Access Compliance Report

Public Rights-of-Way

(Curb Ramps)

Intersection ID: 10024718	Main Street: DEBORAH_DR	Cross Street: N/A	Location: W
ADA ID: 82F8D89345C8	Ramp Type: Perp	Initial Pass/Fail: Fail	Overall Compliance: No
Severity Score: 35			
Codes/Mitigation Info/Possible Solution		Field Measurements/Component Compliance

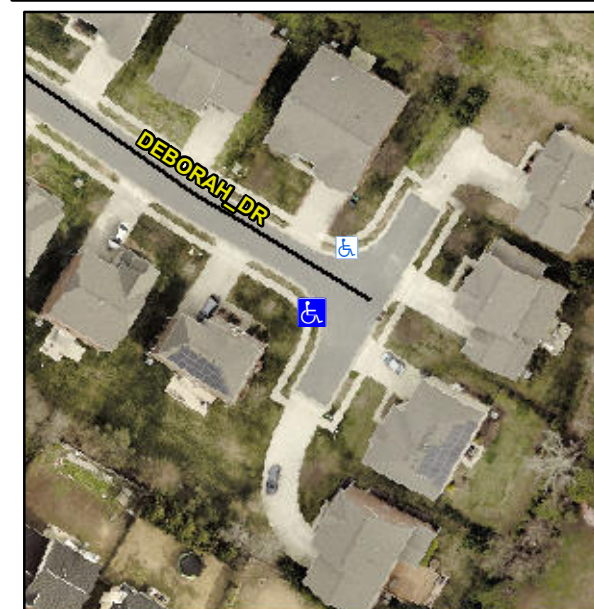
Not Found, R304.5.1, R304.2.2, R304.5.3

Compliance	Description	Data	Compliance	Description	Data
N/A	Ramp Length (in)	48.0	No	Ramp Slope (%)	12.1
No	Ramp Width (in)	43.0	No	Ramp XSlope (%)	3.6
N/A	Flare Type LT	N/A	N/A	Flare Type RT	N/A
N/A	Flare Slope LT (%)	N/A	N/A	Flare Slope RT (%)	N/A
N/A	Flare Traversable LT?	N/A	N/A	Flare Traversable RT?	N/A
N/A	Landing Length (in)	N/A	N/A	DWS Provided?	N/A
N/A	Landing Width (in)	N/A	N/A	DWS Contrast?	N/A
N/A	Landing Slope (%)	N/A	N/A	DWS Length (in)	N/A
N/A	Landing X Slope (%)	N/A	N/A	DWS Full Width?	N/A
N/A	Landing Curb? (Y/N)	N/A	N/A	DWS Offset (in)	N/A
N/A	Shared Landing?	N/A			
N/A	Gutter Ponding?	N/A	N/A	Gutter Slope (%)	N/A
N/A	Gutter Lip Ht (in)	N/A	N/A	Gutter X Slope (%)	N/A
N/A	Painted X Walk1?	No	N/A	Painted X Walk2?	N/A
	X Walk 1 Direction	To NE		X Walk 2 Direction	N/A
N/A	X Walk 1 Width (in)	N/A	N/A	X Walk 2 Width (in)	N/A
	X Walk 1 Slope (%)	2.6		X Walk 2 Slope (%)	N/A
	X Walk 1 X Slope (%)	0.8		X Walk 2 X Slope (%)	N/A

Remove & Replace Entire Ramp.
